ON-SITE SEWAGE DISPOSAL SYSTEM HOWARD COUNTY HEALTH DEPARTMENT BUREAU OF ENVIRONMENTAL HEALTH

ADDRESS: ~~11416 Castle Lane~~ 11674 Route 144 11674 FREDERICK ROAD PROPERTY OWNER: Joseph Anderson

SITE PLAN  
 SECOND REVISED LOT 55  
 KING'S GIFT

# Anderson CABANA

## SITE PLAN

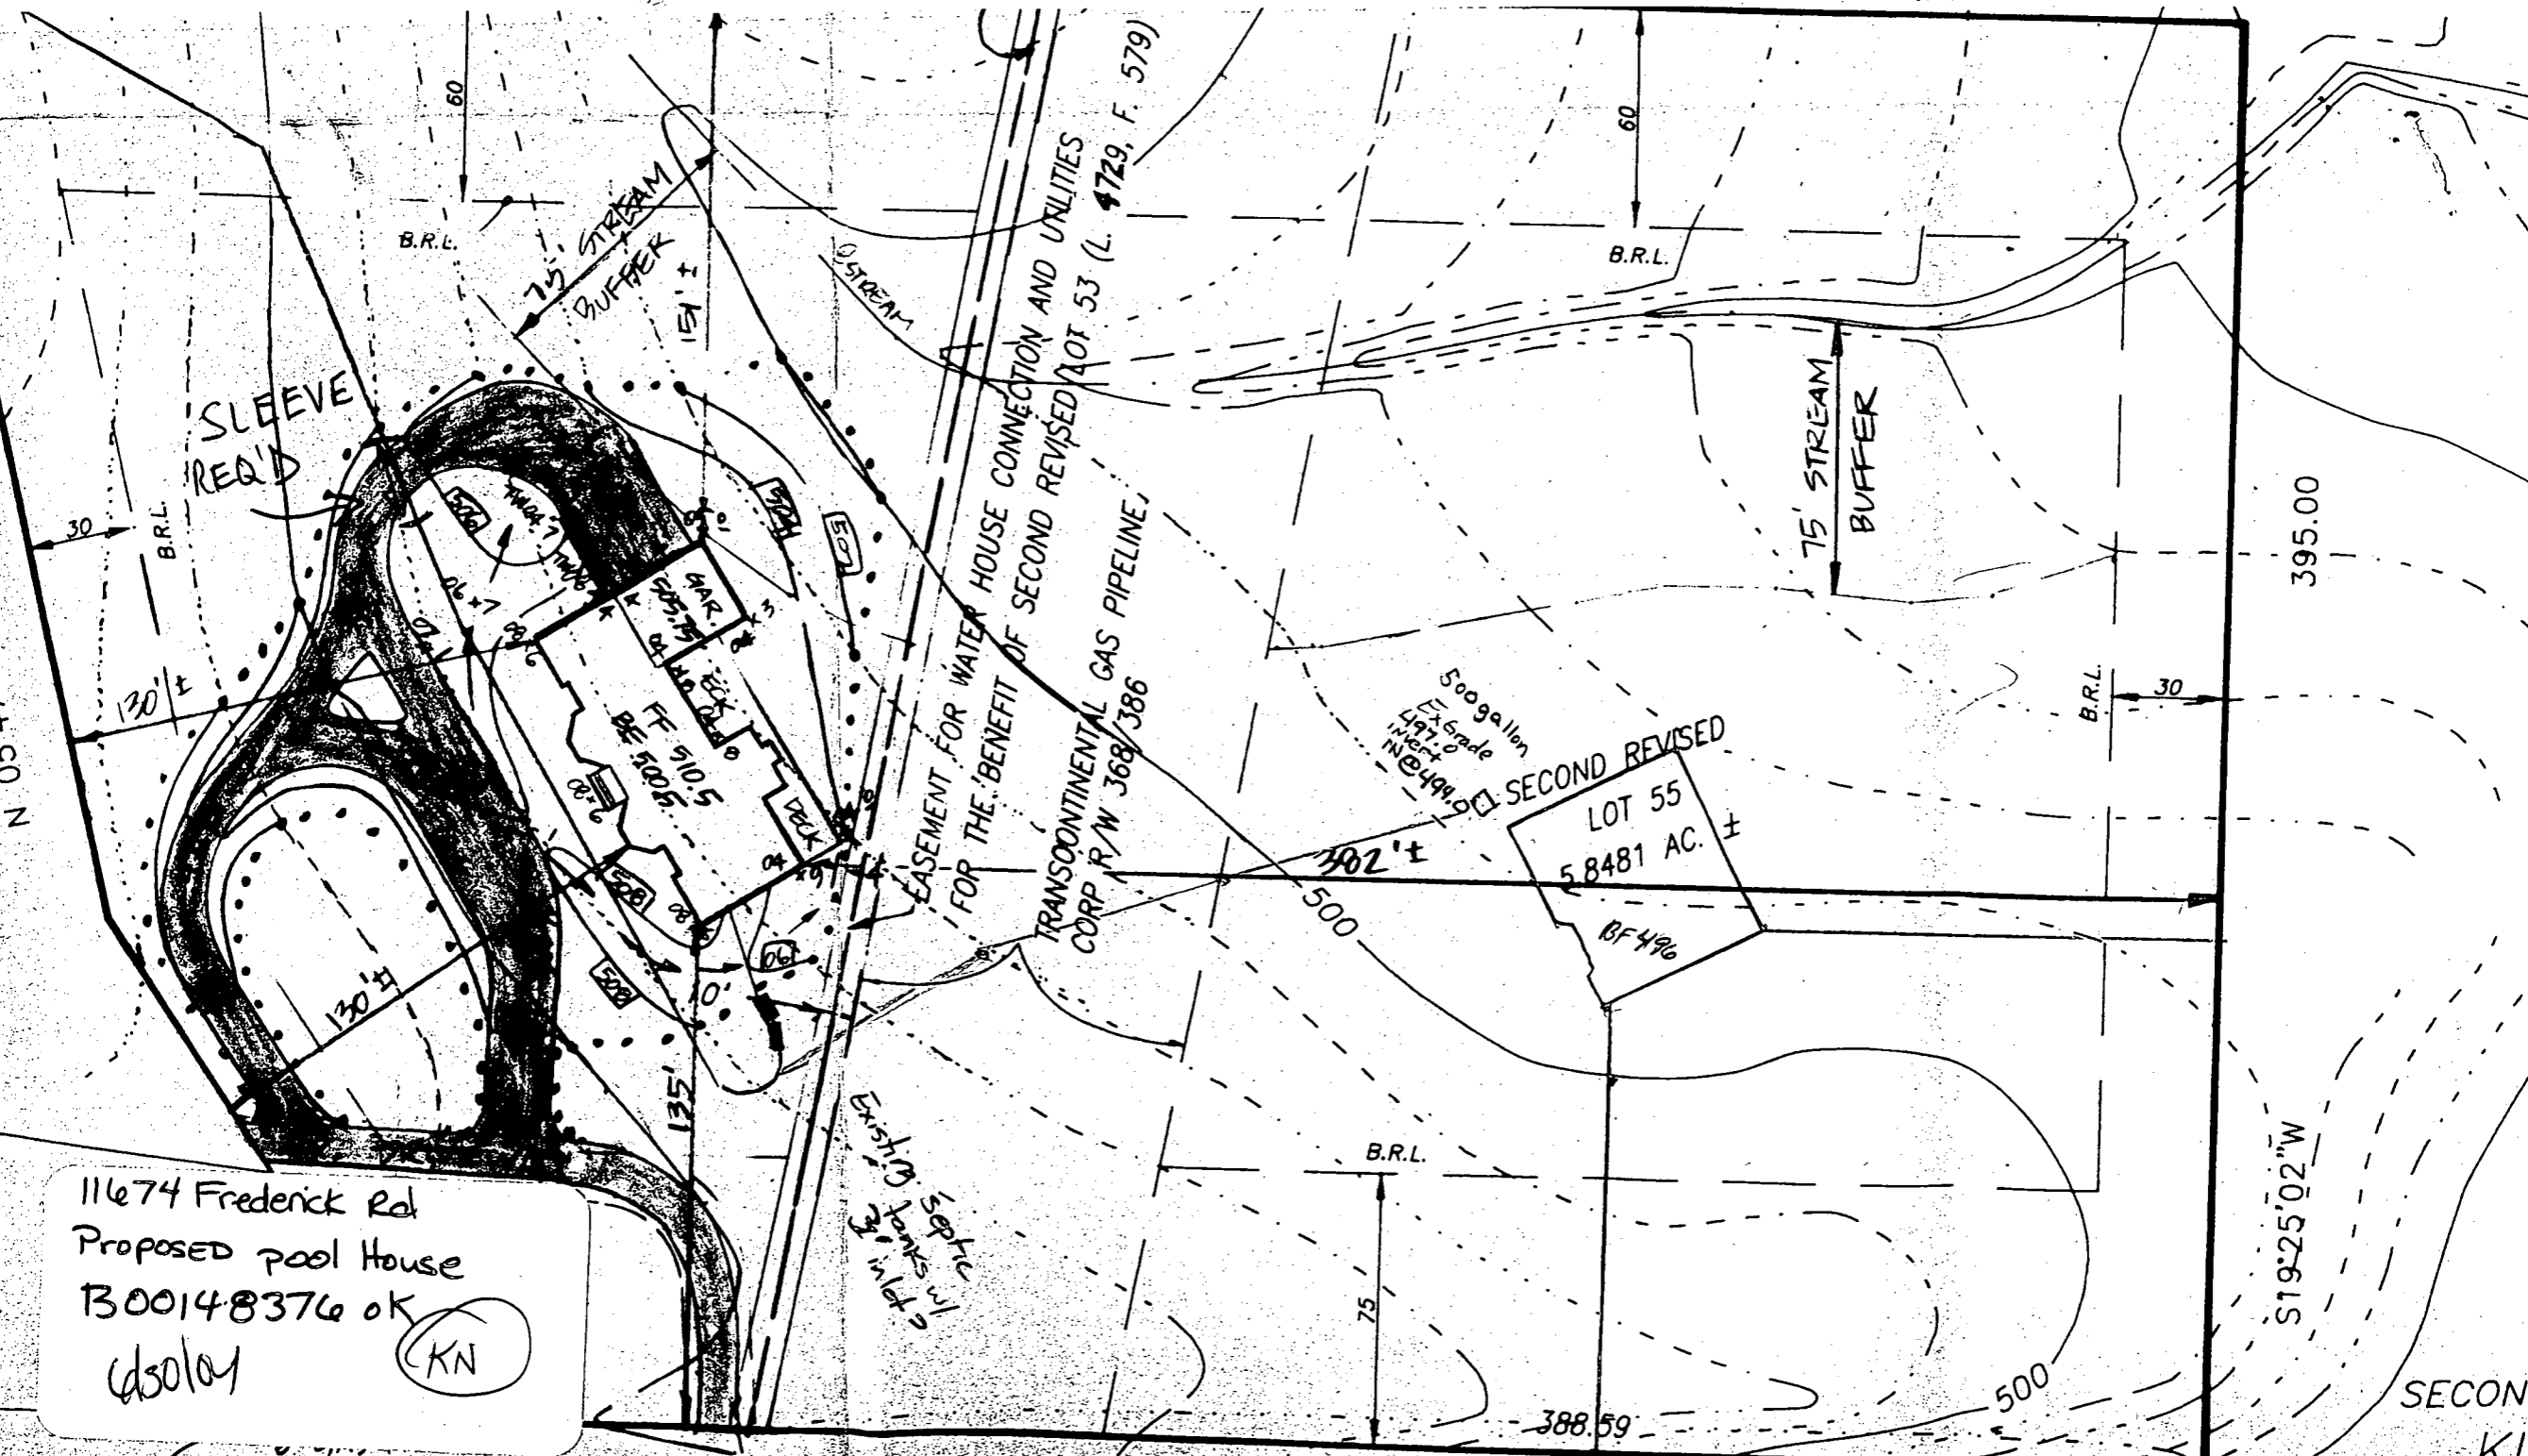
6/11/04  
NEED INVERT ELEVATIONS  
TIEING INTO Ex. line.  
Proposed pool house OK.  
(KN)

6/8/04 KN called again  
for invert & septic tank  
loc.

11674 Frederick Rd  
 Proposed pool House  
 B00148376 OK  
 Wsola  
 (KN)
